# Current ENERGY STAR Single-Family New Homes Policy Record

## Current ENERGY STAR Single-Family New Homes Policy Record

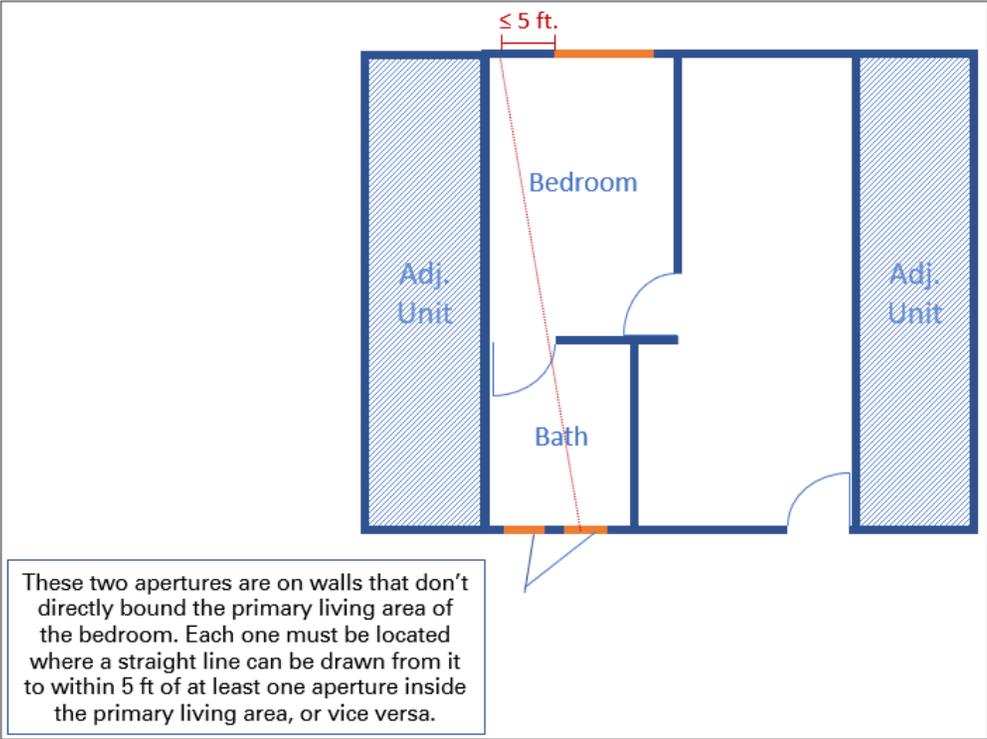
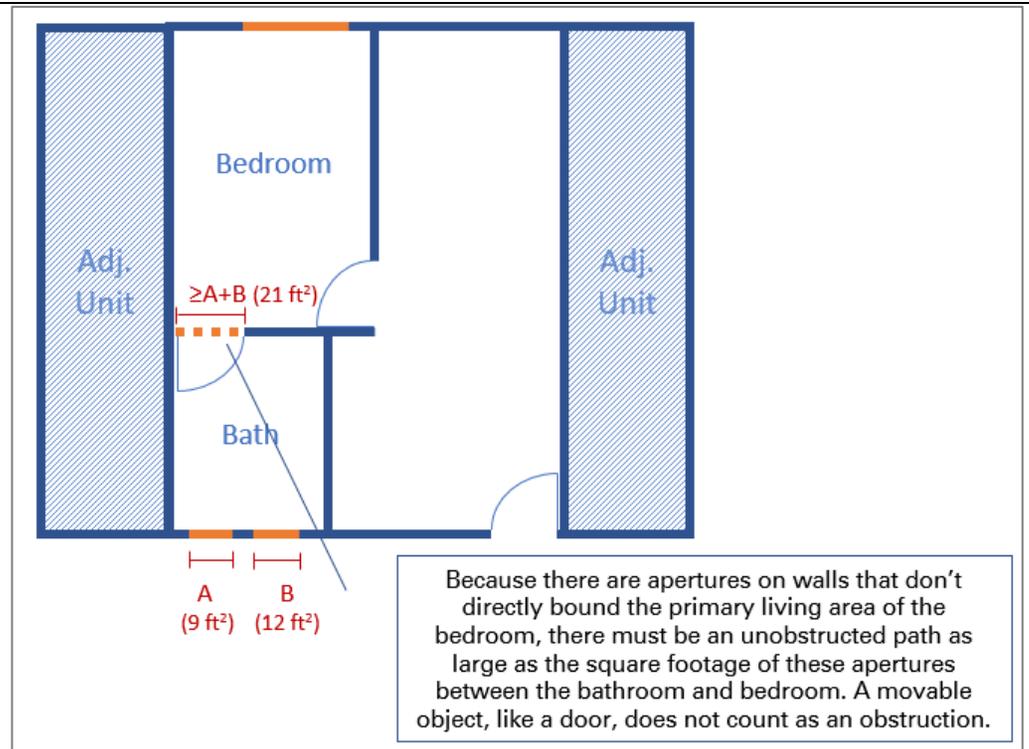
If apertures must be on walls that directly bound the primary living area, then there is no way to meet this Item unless the design incorporates wing walls, which stakeholders have indicated are not common practice.

Allowing apertures to be located on walls outside the primary living area would ease compliance while not necessarily compromising the original intent of the requirement, to promote effective natural ventilation.

**Resolution:** Clarifying the requirements for aperture location will promote consistent implementation of the program requirements, while adding a pragmatic allowance that does not alter the original intent of the requirements.

Apertures will be allowed to be located outside the primary living area if they meet two prerequisites that promote effective natural ventilation. Namely, the apertures outside the primary living area must be effectively aligned with at least one aperture inside the primary living area. More effective ventilation should be promoted by not allowing circuitous or obstructed routes between apertures.

Specifically, this intent can be conveyed by recommending, but not requiring, apertures to be on walls that directly bound the primary living area.

Furthermore, apertures outside the primary living area can be required to be “effectively aligned” with at least one aperture inside the primary living area, where an aperture is “effectively aligned” if a straight line can be drawn from one aperture to within 5 ft. of the other aperture. See Exhibit 2.
